Informal document **GRB-53-21**  
(53<sup>rd</sup> GRB, 15-17 February 2011,  
Agenda item 3(c))

# Update of NL ASEP proposal

(doc GRB-2011-08)

issued by the Netherlands

# Effect of Chair part 1 proposal

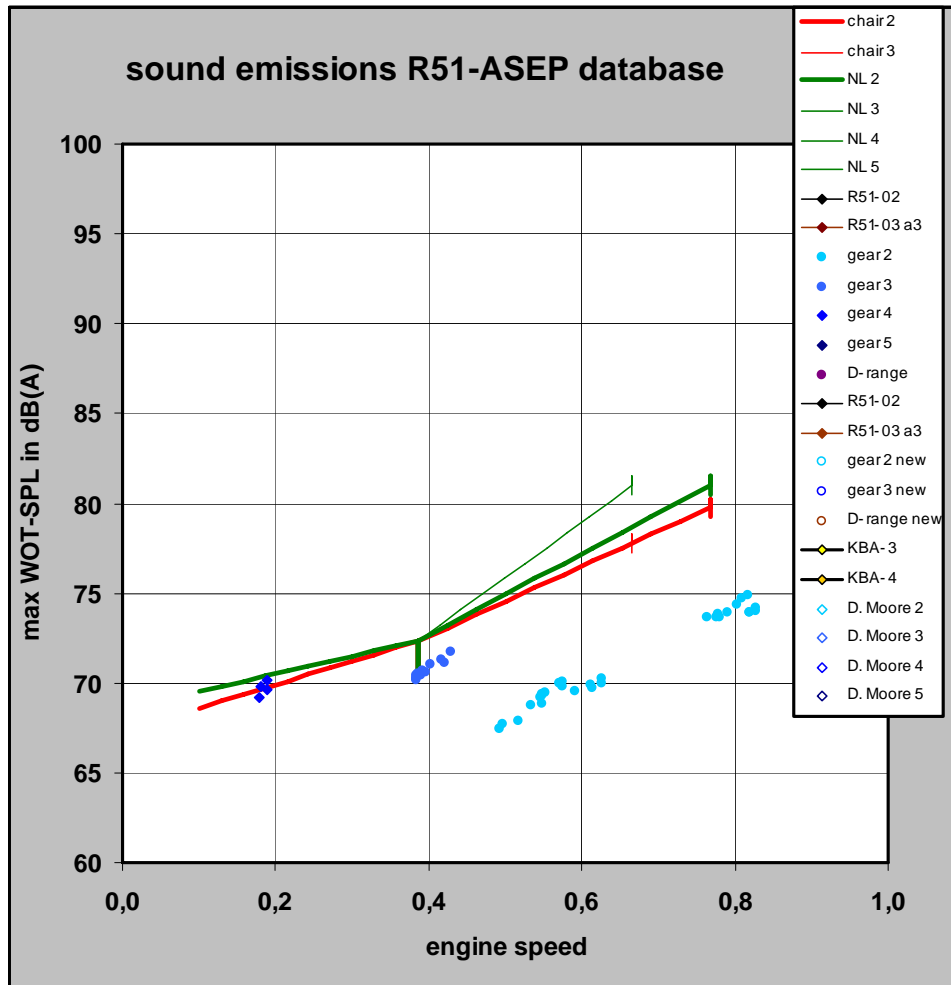
- 17% of uncritical vehicles fail
- 64% of vehicles of concern pass

# Relevance of the bonus

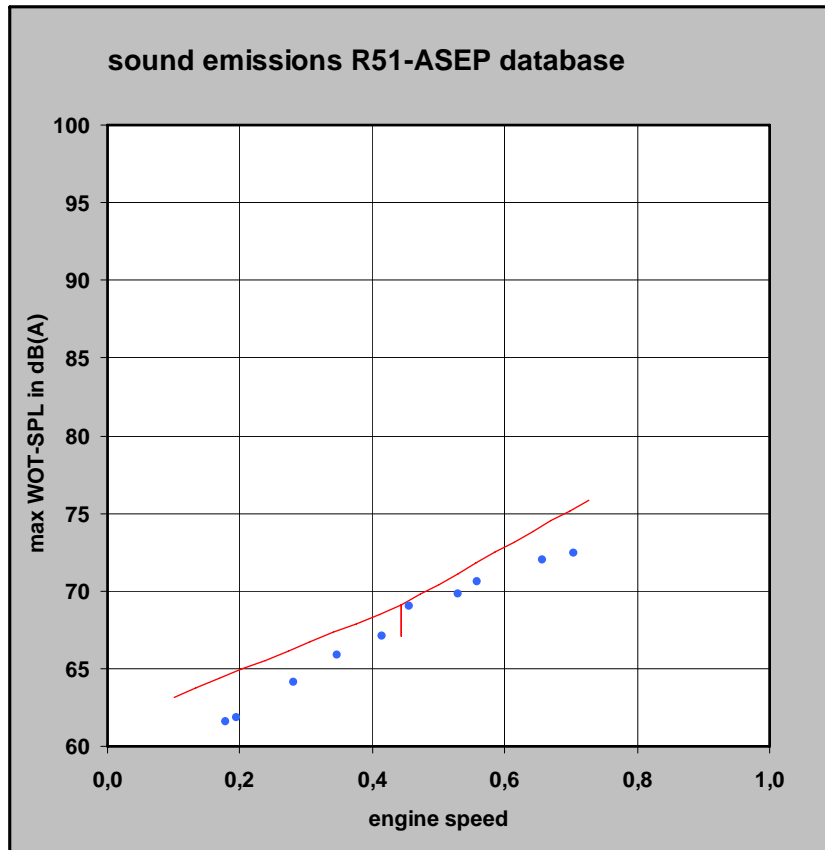
Without bonus 'jumps' are punished

With bonus: silent vehicles will pass tougher limitation options

No bonus → more vehicles rejected → supports pleas for weaker limitation

example vehicle: 5,5 dB under Annex 3 limit (veh 1-26)

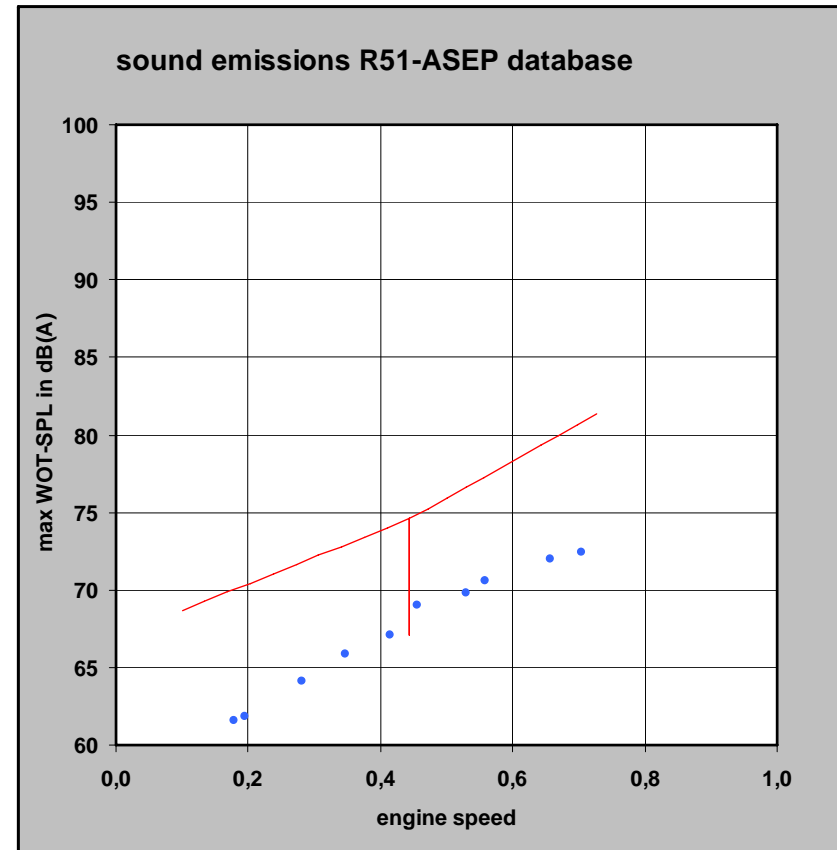
Without bonus  
ASEP becomes critical  
 $\Delta = 0,4 \text{ dB(A)}$

With bonus  
ASEP is uncritical  
 $\Delta = 6 \text{ dB(A)}$

vehicle of concern: early jump allowed

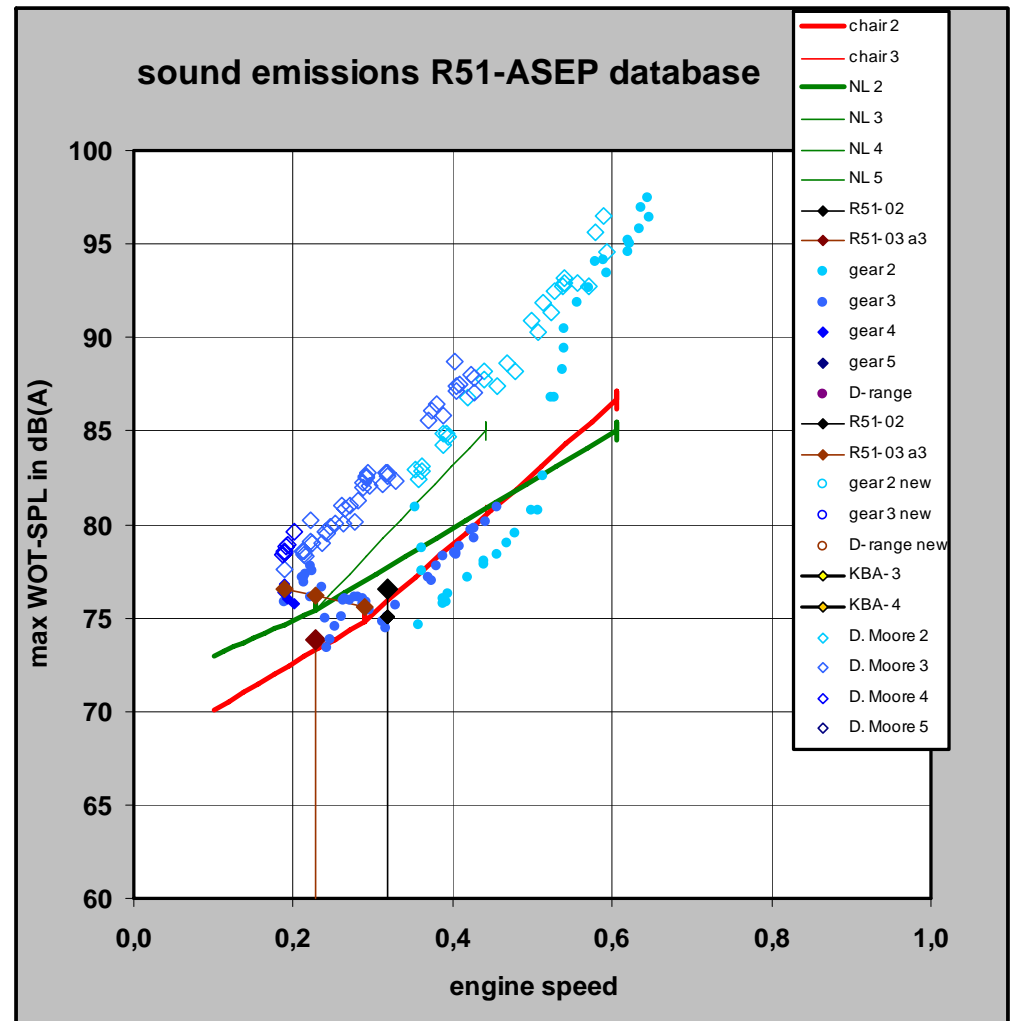
- Vehicle 200-09
- PMR 159 kW/t
- Assumed limit A3: 72 dB(A)
- $L_{\text{urban}}$  ASEP more liberal than
  - Chair ASEP (5-10 dB)
  - NL ASEP (3-12 dB)
  - R51.02 (7 dB)

## noisy vehicle > 100 dB allowed

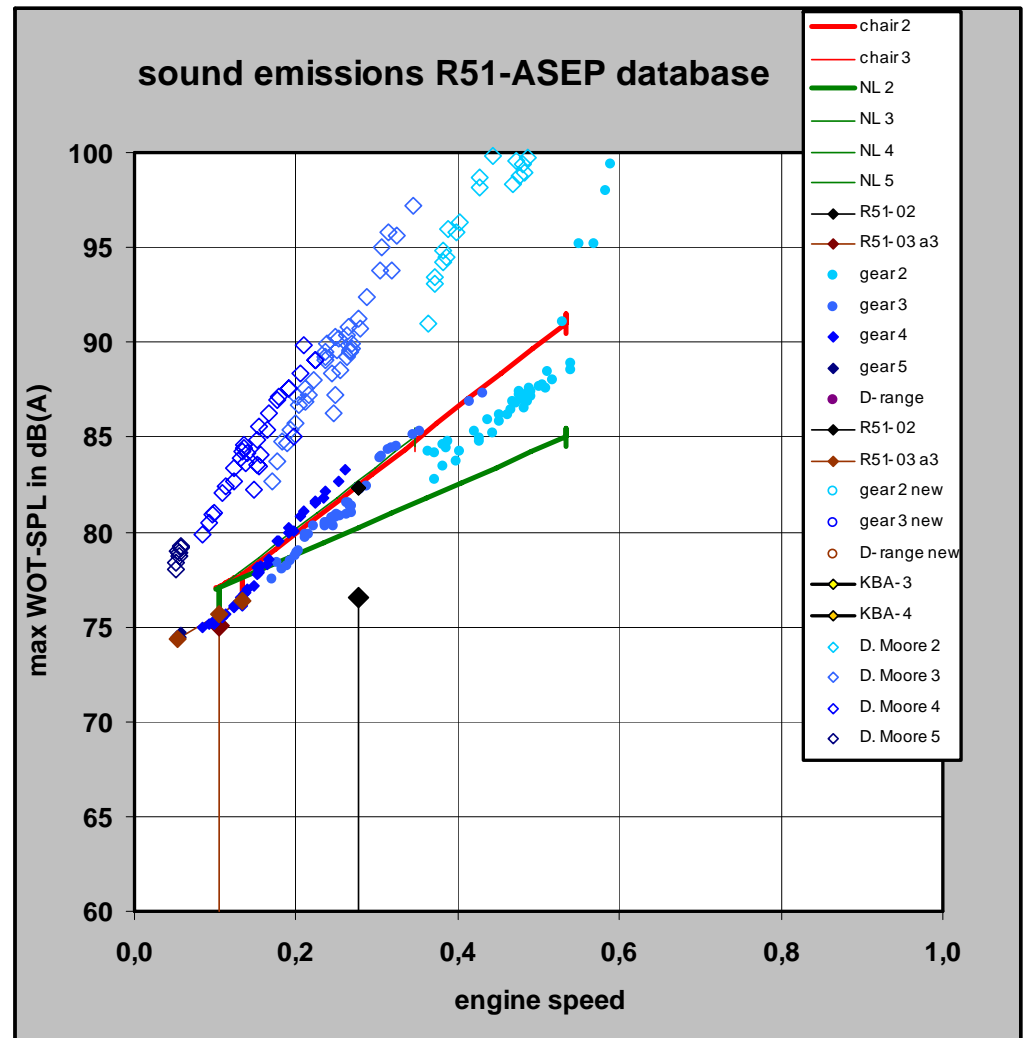
- Vehicle 200-16
- PMR 239 kW/t
- Assumed limit A3: 73 dB(A)
- $L_{\text{urban}}$  ASEP more liberal than
  - Chair ASEP (5-15 dB)
  - NL ASEP (5-20 dB)
  - R51.02 (15 dB)
- **Note:** significant spread in Lurban limit due to spread in acceleration

# Example Lurban ASEP sensitivity

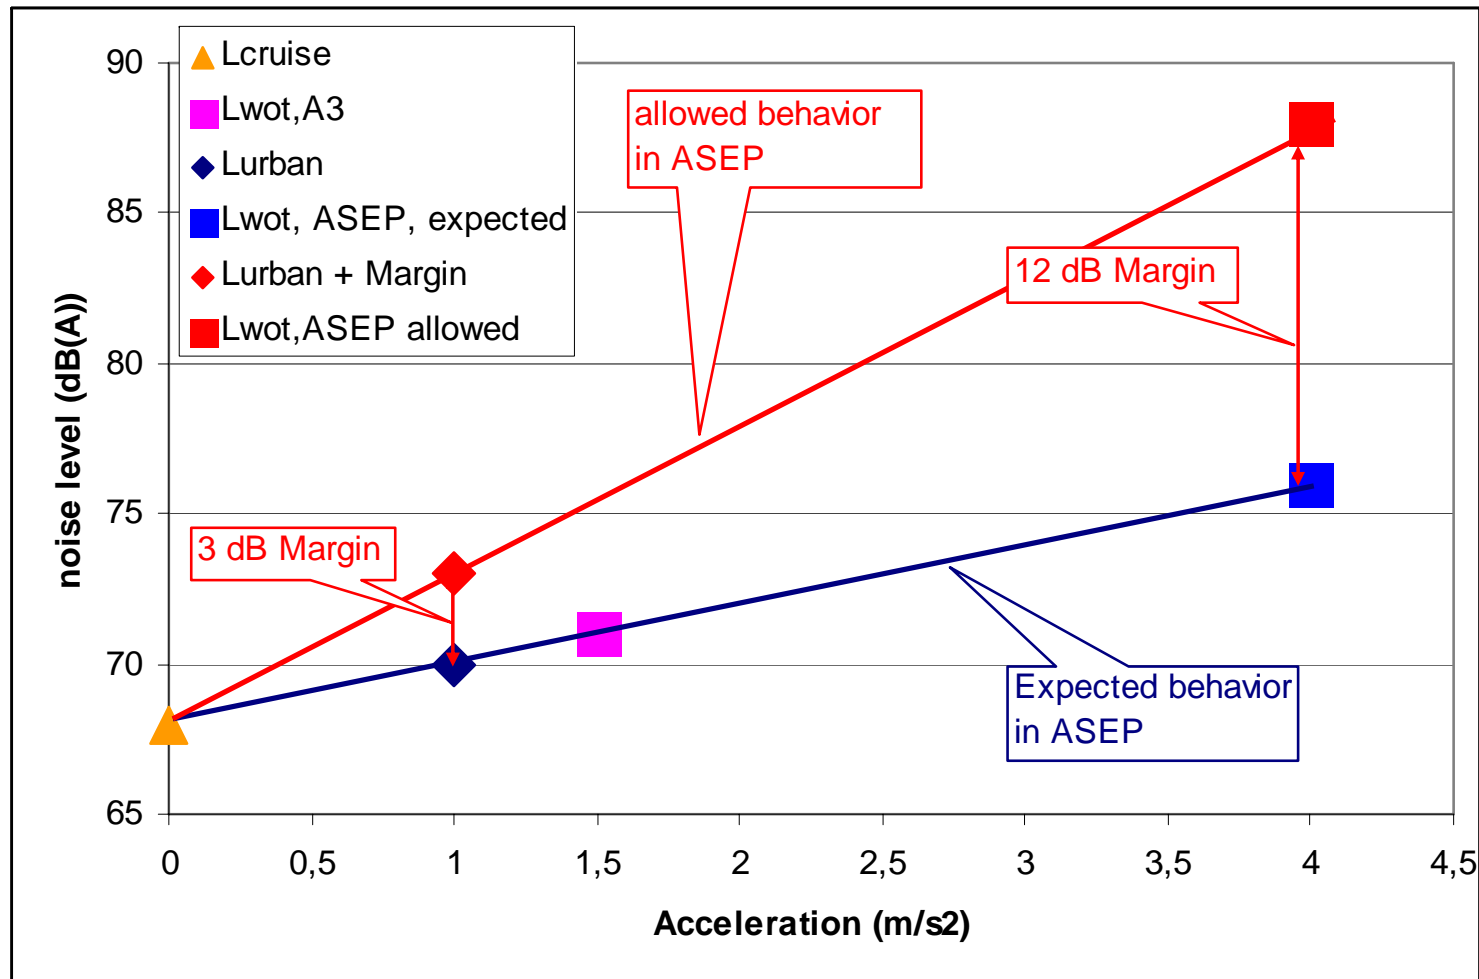
- Consequence: 12 dB Margin in Lwot,ASEP
